August 3, 1984

HOPE CREEK GENERATING STATION  
DOCKET NO. 50-354  
DRAFT SAFETY EVALUATION REPORT  
OPEN ITEM STATUS

In addition, enclosed for your review and approval (see Attachment 4) are the resolutions to the Draft SER open items, FSAR question responses and structural geotechnical audit item responses, listed in Attachment 3.

FIGURE A-13-27

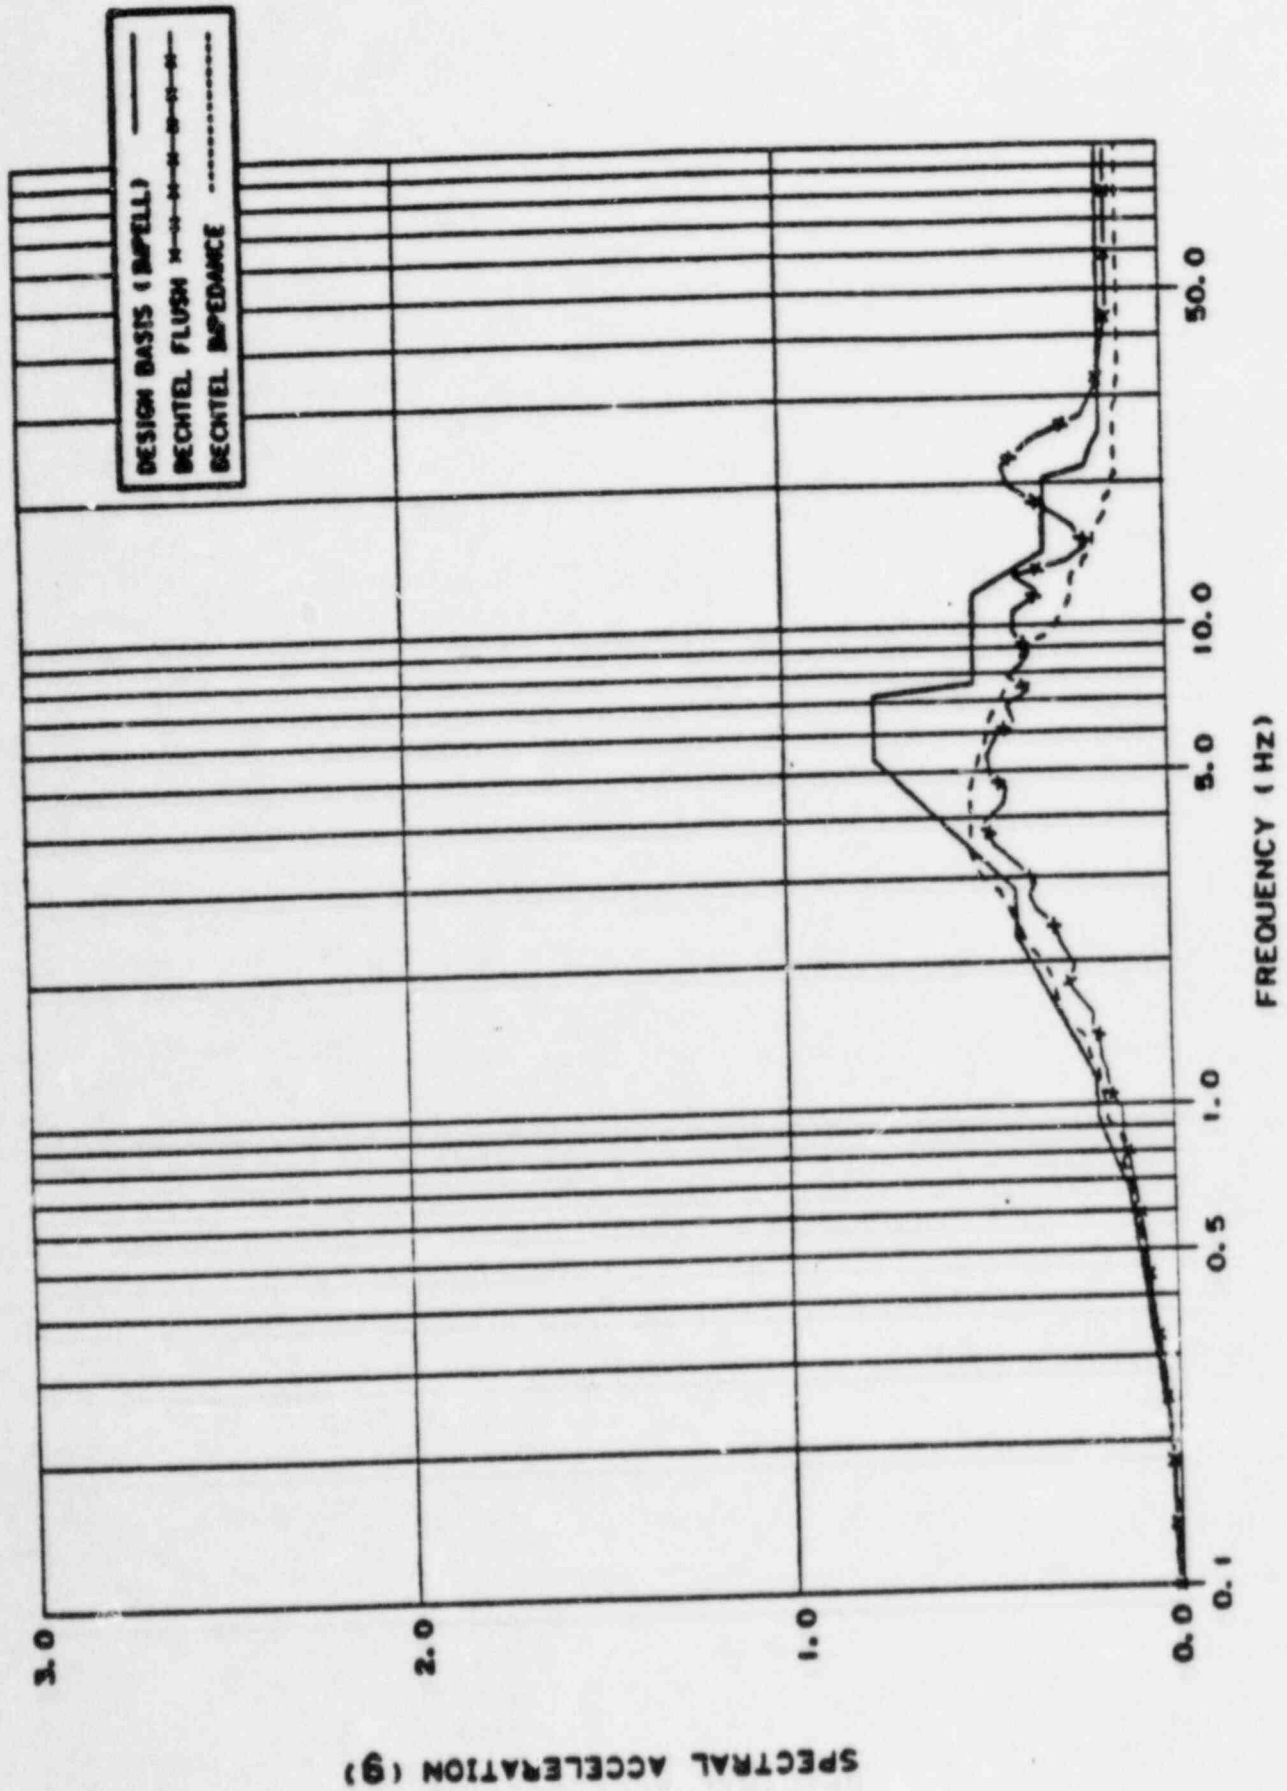
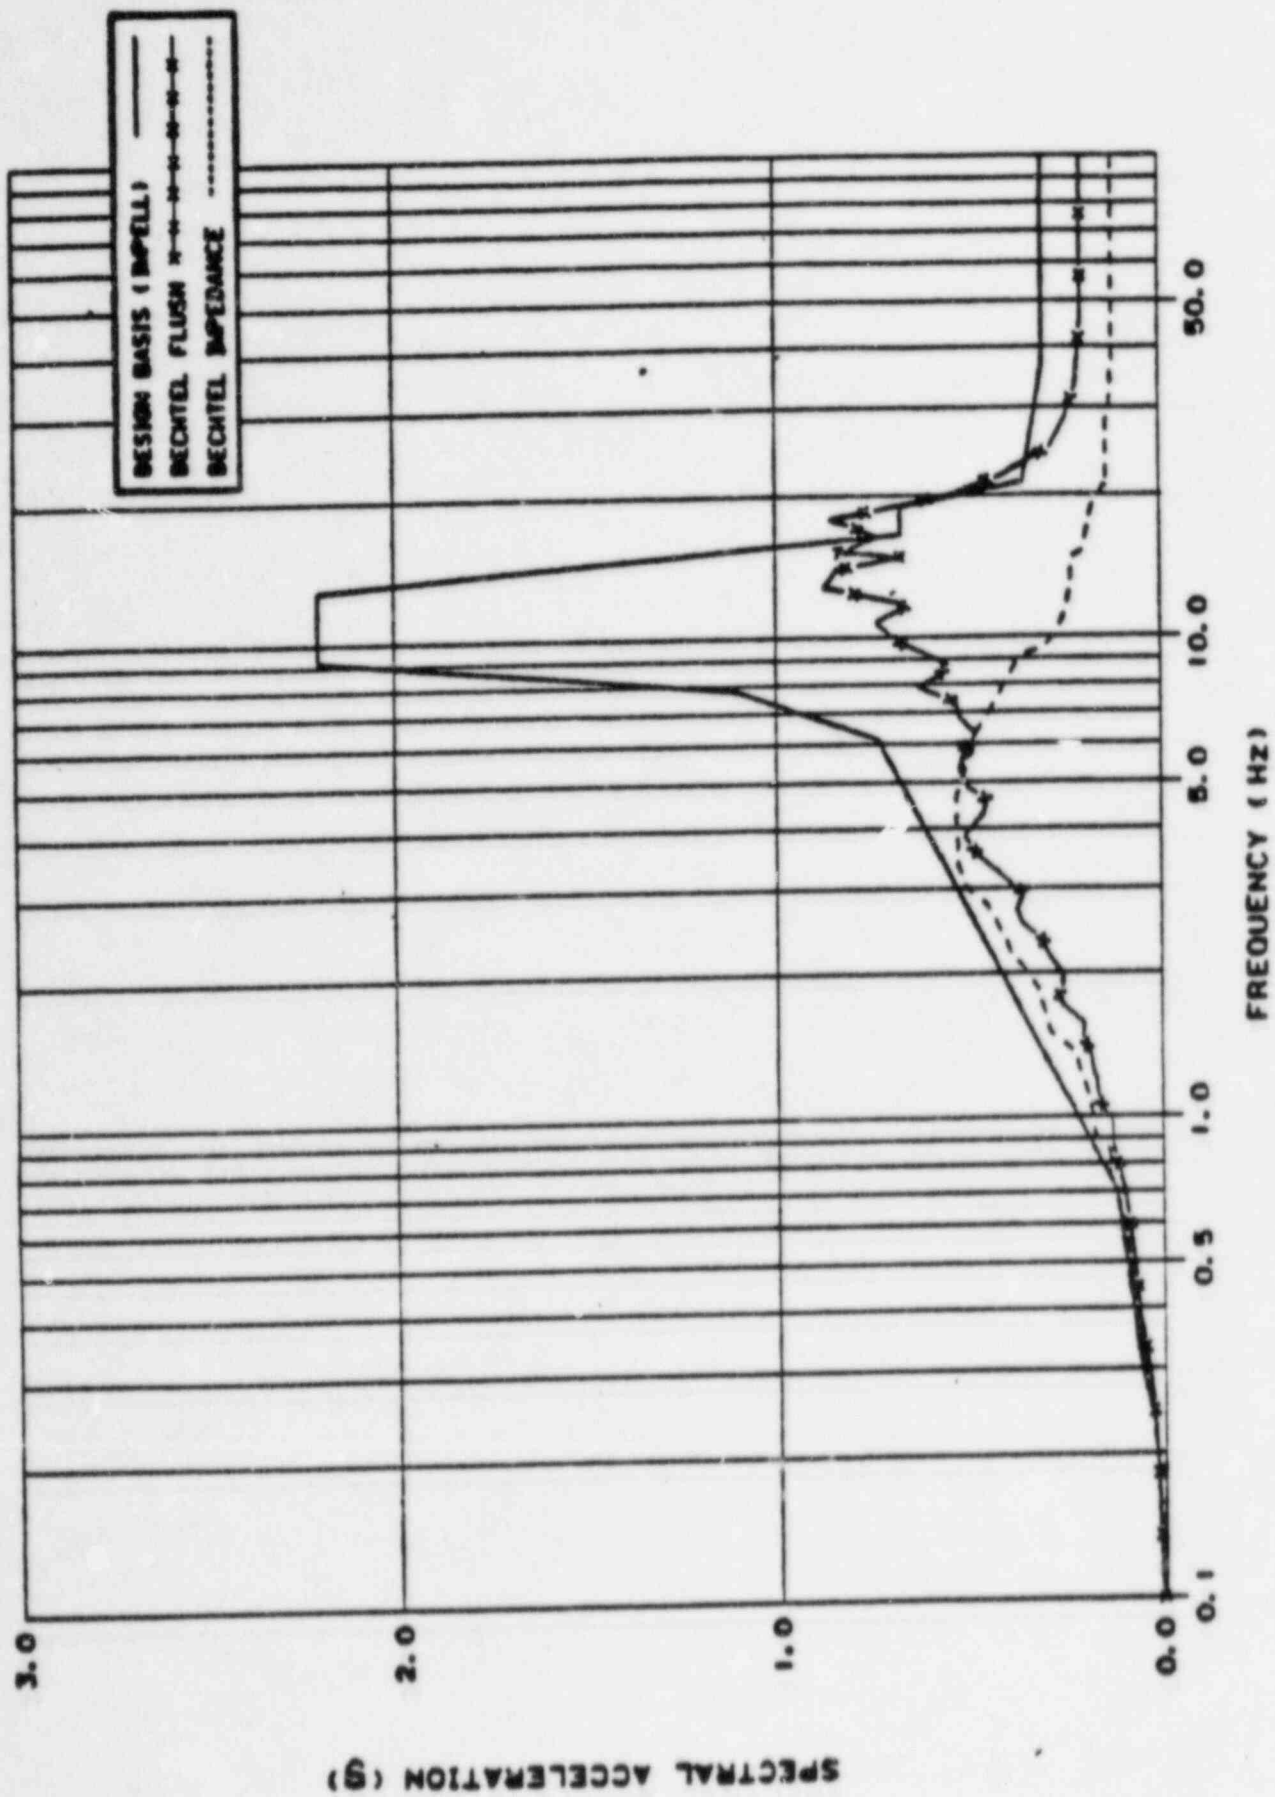
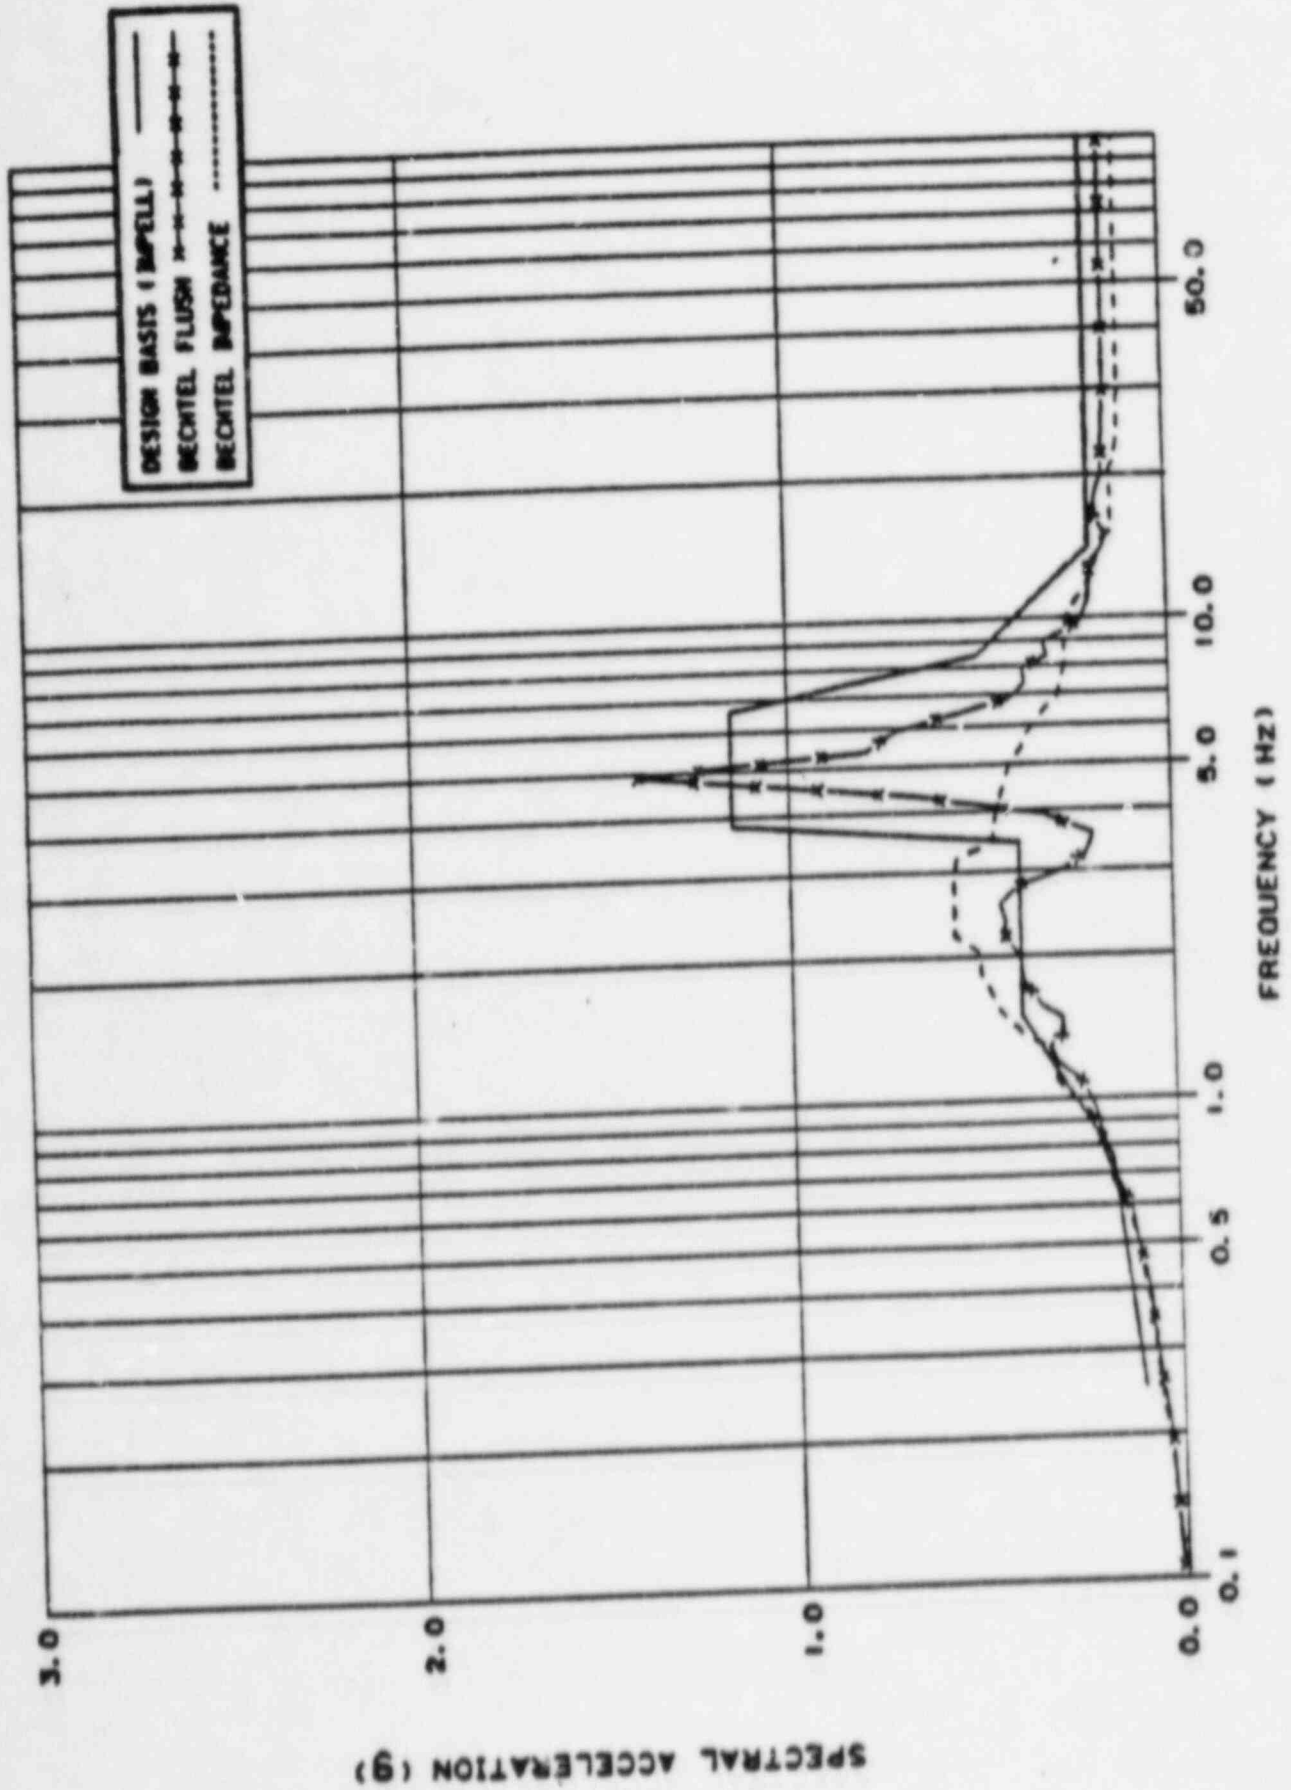
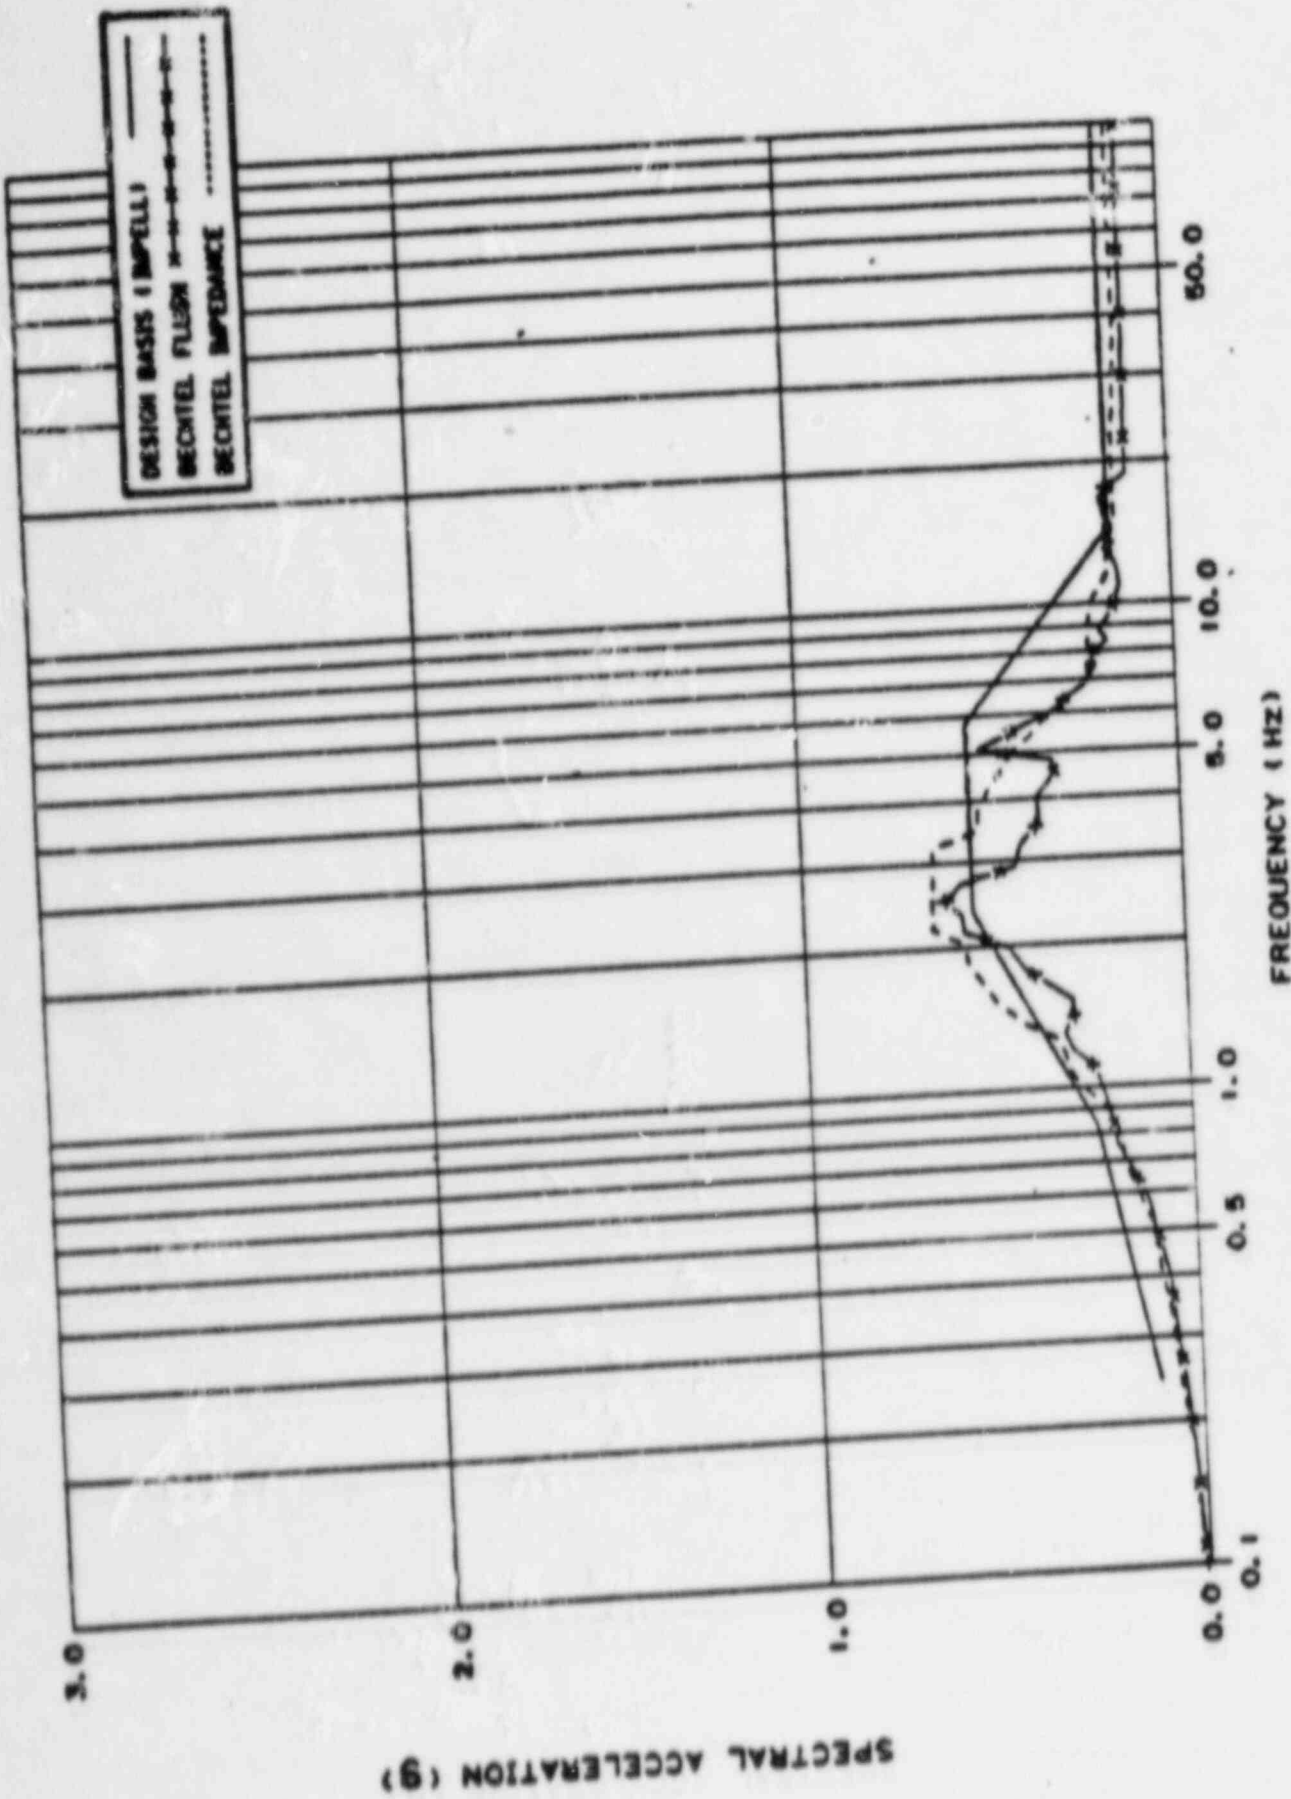
Question: Provide comparison of Bechtel Independent Verification Results with the Design Basis Results.

Figures A-13-2 to A-13-37 show the comparison of the response spectra (2% damping) obtained from the above three seismic soil-structure interaction analyses. Discussions of these comparisons are as follows:

Bechtel's independent soil-structure interaction analyses are performed using the computer code FLUSH. The results of independent finite element analyses are in reasonable agreement with those of the design basis analyses. As can be seen from Figures A-13-2 through A-13-37, the horizontal response spectra obtained from the independent finite element analyses are generally enveloped by those obtained from the design basis analyses except for the frequency range lower than 2 Hz. The vertical response spectra showed some exceedances at the frequency range of 18 Hz. These exceedances are listed in Table A-13-1.

The peak spectral accelerations obtained from the impedance approach analyses are generally lower than those obtained from the design basis analyses. However, these response spectra are not completely enveloped by those obtained from the design basis analysis, especially in the frequency range between 1.0 and 3.5 Hz. Also, there are some local exceedances in the higher frequency range, as shown in Figures A-13-2 through A-13-37.
